MCAS new MVS algorithm simulation with AOA sensor upset - supporting explicative

NOTE: This was initially put together quickly as an aid on how to employ the simulation tool Excel file, along with the overall explanation of why I think this is a massive problem, for the purposes of the relative emergency to discuss this with TCCA ASAP. Gilles Primeau, December 3rd 2020. Adapted for transmission to EASA December 14th 2020.

Upset Sensor with Maneuver MVS Algorithm Behavior

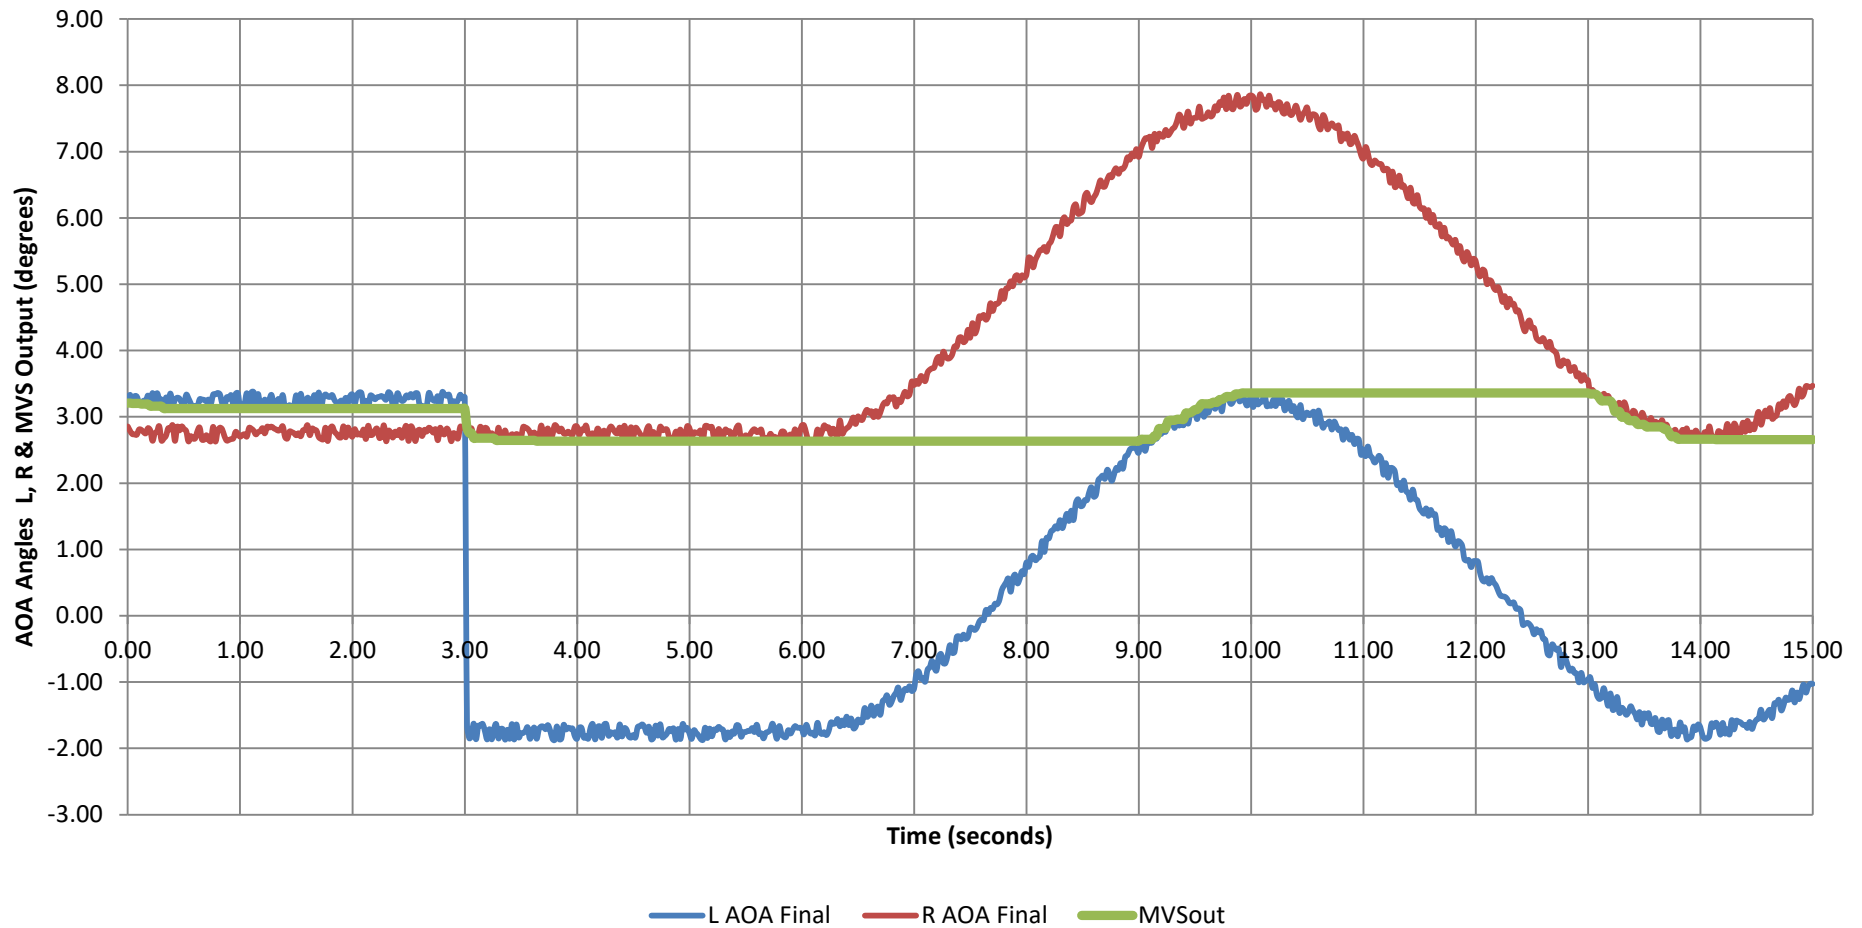
Please review the image on the next page, illustrating one of many possible embodiments of the identified failure condition; postulate a need for a sudden maneuver, nose up, to avoid an obstacle. Look at the red trace showing the good AOA (unaffected R sensor) that comes with this maneuver. I don't know the real AOA numbers that apply to the 737 MAX, but that's besides the point; this shows what WILL happen, following an undetected upset, to here the L AOA (in real life this is fully symmetrical L-R), that biases DOWNWARD its readout by less than 5.5 degrees (which is the threshold Boeing has encoded in their logic for the split-vane monitor). As you can probably see from this graph, the correct red trace moves the aircraft toward stall detection territory (with accompanying stick shaker and increased control column pull-back forces if it reaches the trigger threshold), while the green trace shows that with this MVS logic, the MCAS input will be biased downward by 5 degrees in this example, causing the MCAS NOT to trigger when it SHOULD, due to the upset L AOA in the blue trace, thus breaking down proper functioning of the nominal MVS algorithm intended to provide a higher integrity AOA input to the MCAS. Under this latent failure scenario therefore, instead of forcing the aircraft nose down through an erroneous MCAS activation as occurred on JT610 & ET302, the MCAS might not intervene when required to, risking a stall.

We call such cases UNANNUNCIATED or latent failures (because of the lack of detection, since the algorithm allows up to 5.5. degrees before declaring the split-vane magnitude too high); some also call them latent failures, or dormant failures. They are massively dangerous, because lack of detection will cause NO cockpit warning telling the crew the MCAS is compromised, thus misleading the crew into thinking the MCAS is still there so prevent the stall, which will NOT happen. Note this carefully: Authorities, TCCA in particular, have pushed for more training; the training covers cases with MCAS, and without MCAS, however with reliance on proper crew messaging to know whether MCAS is active or not; here, the crew would mistakenly think the MCAS still functions normally while it in reality does not, and could get caught off-guard because MCAS did not activate, if an obstacle avoidance maneuver is required, for instance. In the example figure, all the area below the red trace and above the green trace, defines the zone under which the MCAS is unable to perform its required function due to the upset that affected the L AOA. This upset is of exactly the same type as what occurred on ET302, but with a different sign and a much lower amplitude. Don't be misled by the lower value compared to the 20 deg AOA delta on JT610 or 60 deg AOA delta on ET302; this improper MVS intended to merge the two AOA signals to feed the MCAS primary input, is HUGE for any aerodynamicist comparing this value with the AOA for maximum lift coefficient (I usually employ 12 degrees for CLmax as a first order estimate before putting my hand on actual aircraft-specific data); in this example, one can see the MCAS protection is biased down by around 4.5 degrees (distance between red and green traces at the peak of the maneuver); this is massive, in my view.

(*) Again that's how Boeing chose to merge the new usage of two AOA vanes in their revised MCAS software. The identified failure condition demonstrates its inadequacy, and my current opinion is that **only a true 3-sensor approach, even if the 3rd source is synthesized (as long as independent of the 2 existing AOAs), per EASA demand, would resolve this UNSFAE condition, and should thus be imposed prior to re-certifying the MCAS.**
